DOCUMENT 00 90 00
ADDENDUM

ADDENDUM NO. [3] Date: November 7, 2018

**RE: PRENTICE SCHOOL DISTRICT
 ADDITION AND REMODELING BID PKG 3
 1025 TOWN ST
 PRENTICE, WI 54556
 HSR PROJECT NO. 18022**

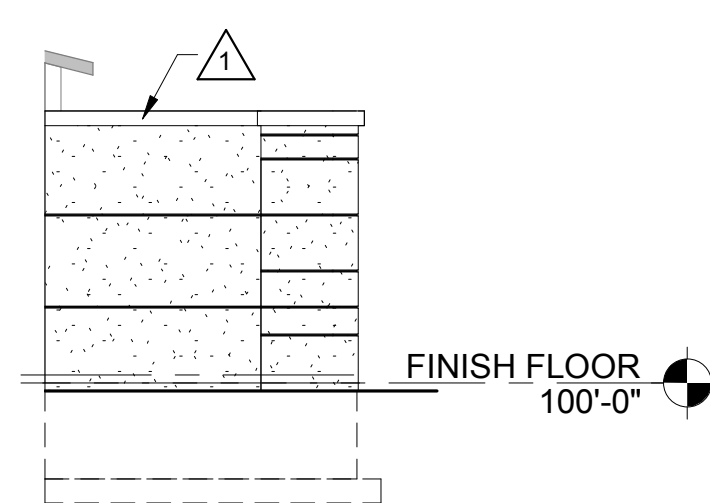
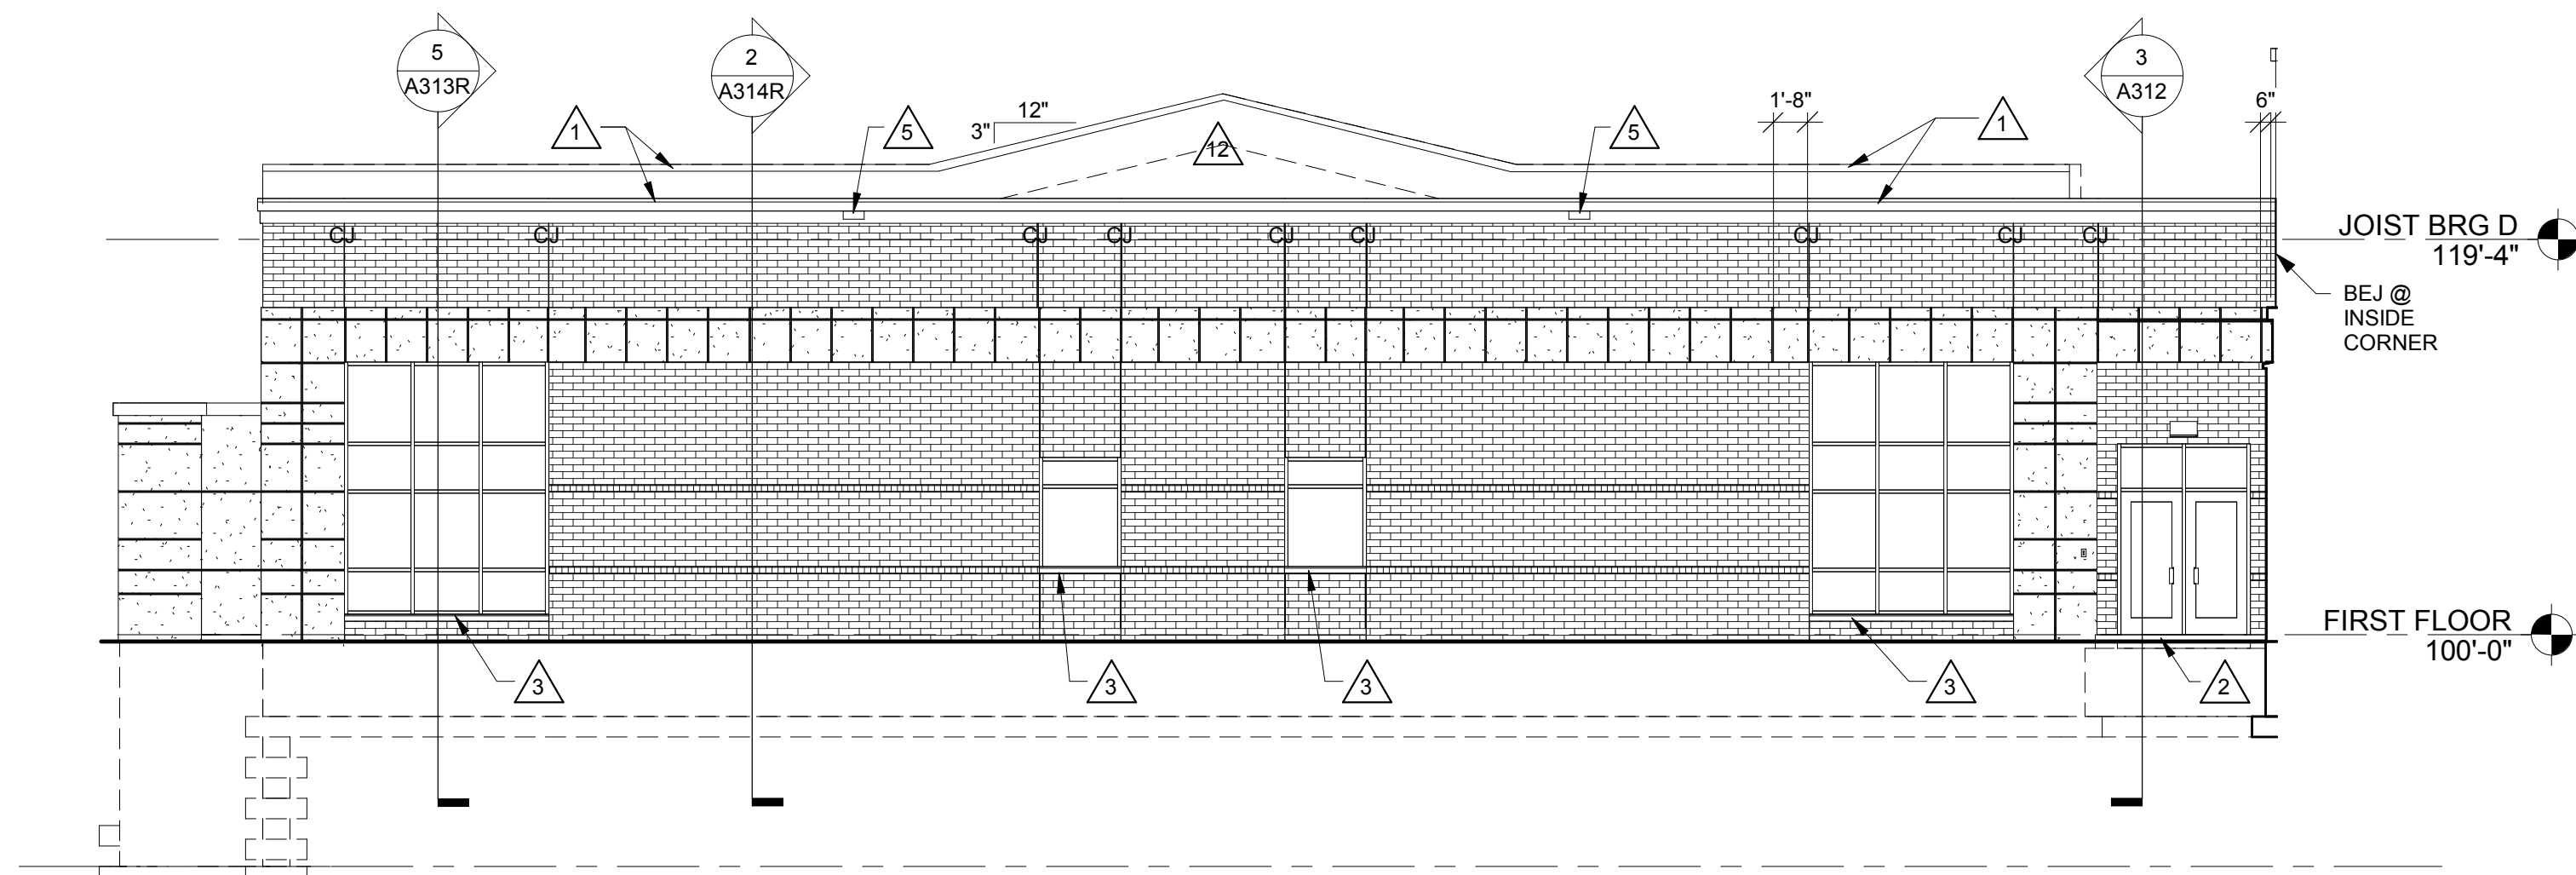
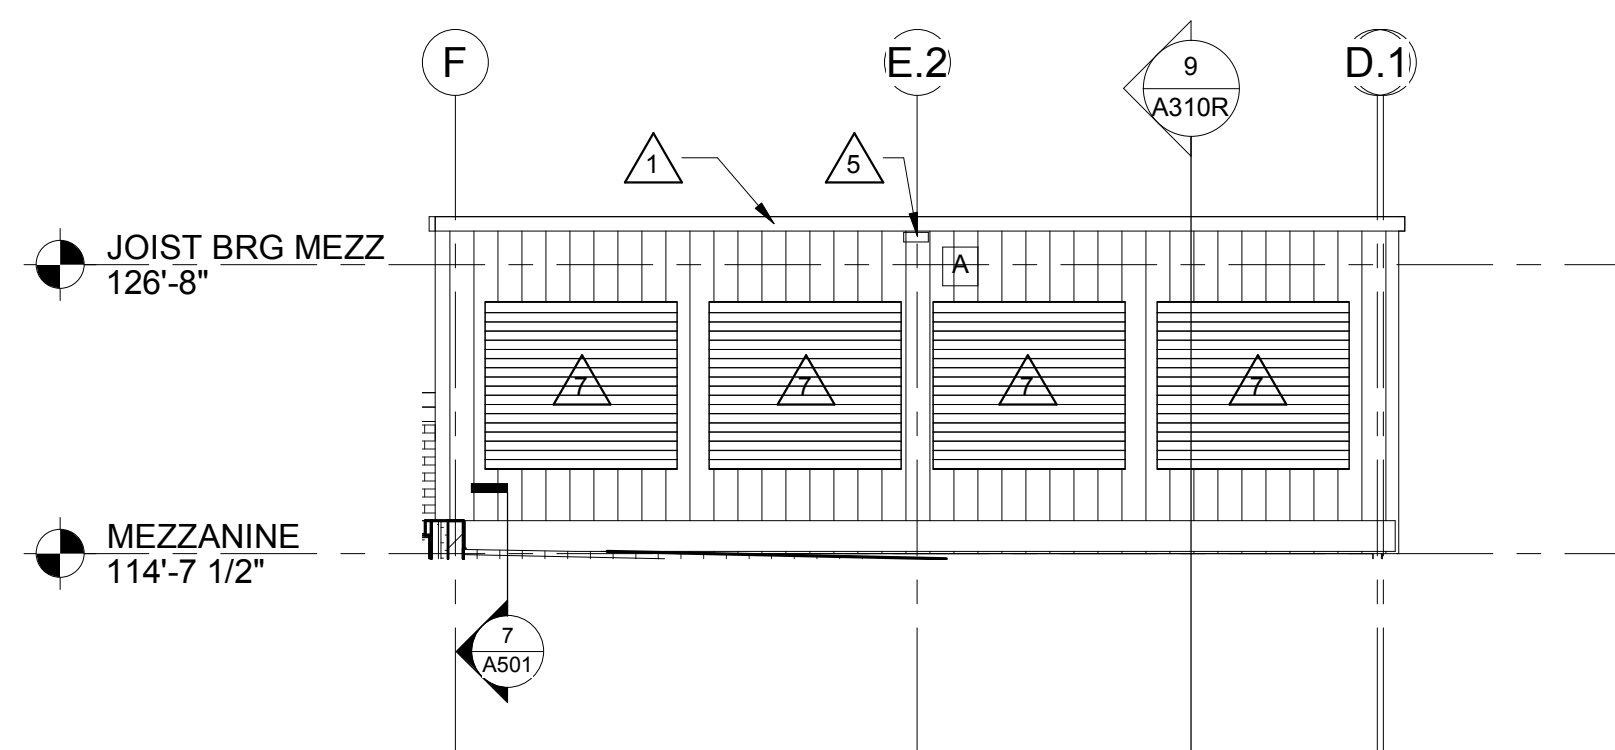
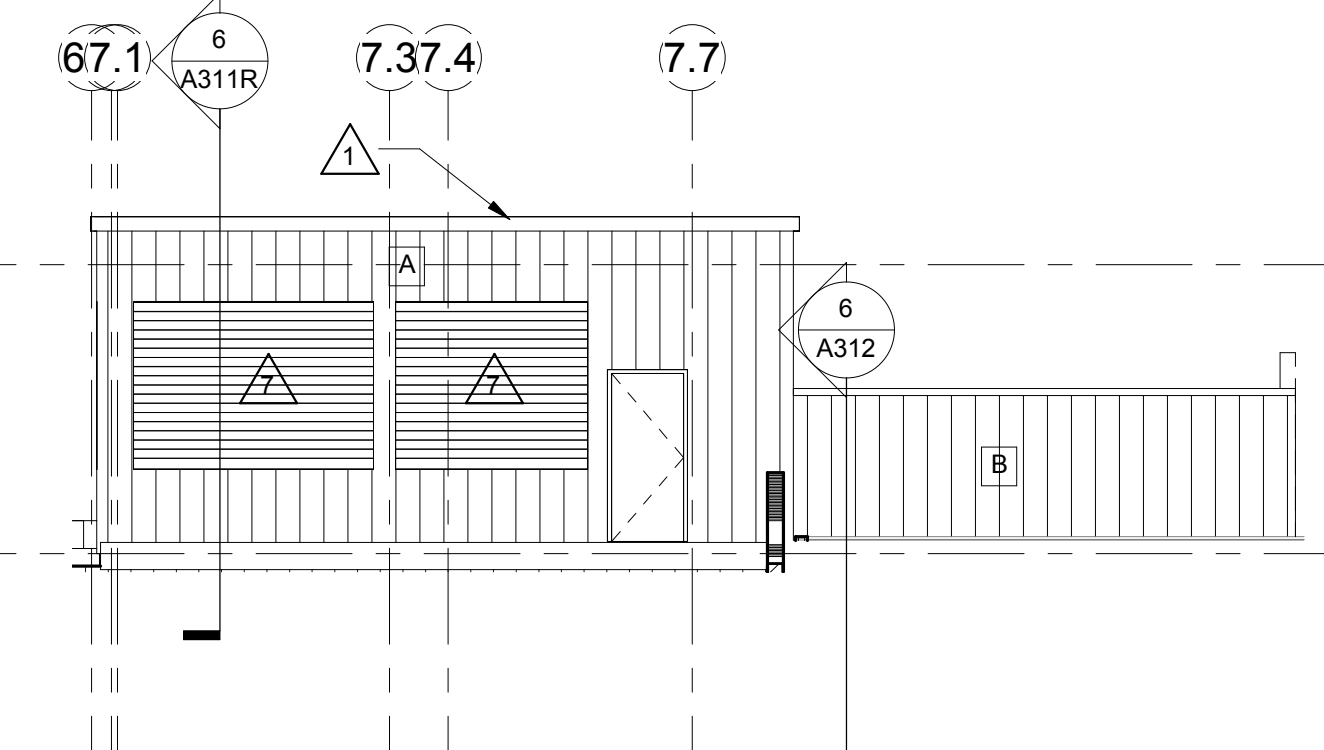
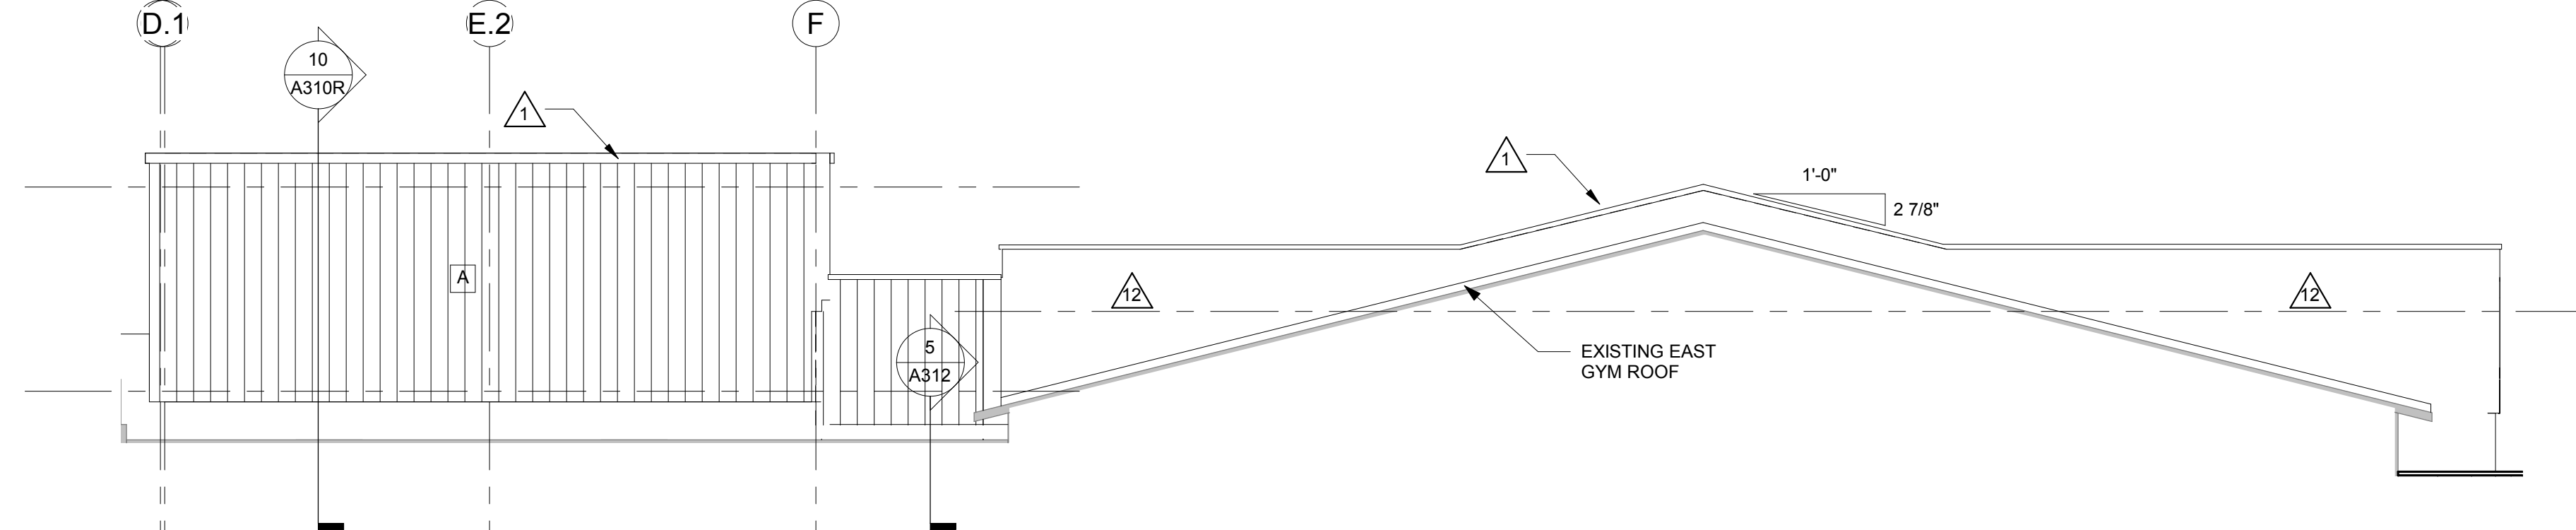
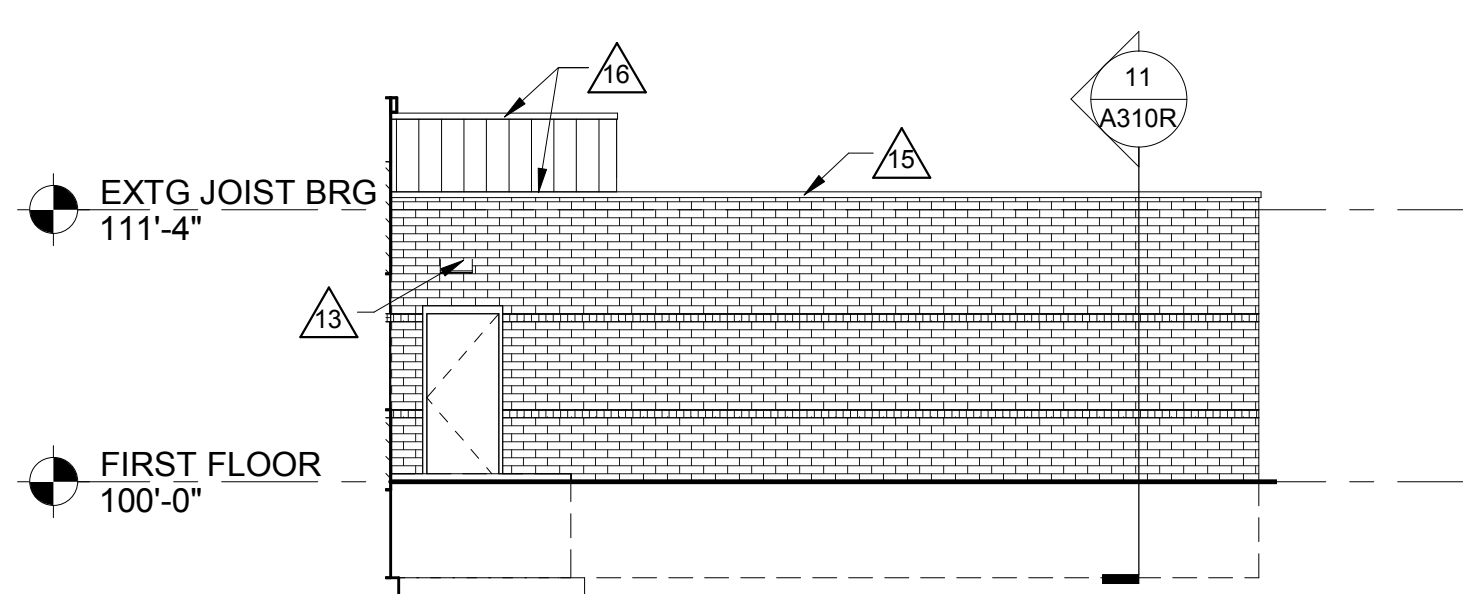
1. Sheet A112R FLOOR PLAN UNIT B 30 x 42 attached hereto
 - a. Revisions clouded on Drawing.
 - b. Revised extents of brick at northwest CORNER.
2. Sheet A201R EXTERIOR ELEVATIONS 30 x 42 attached hereto

- a. Revisions clouded on Drawing.
 - b. Revised extents of brick at west wall
3. Sheet S002R STRUCTURAL SCHEDULES 30 x 42 attached hereto.
 - a. Revisions clouded on Drawing.
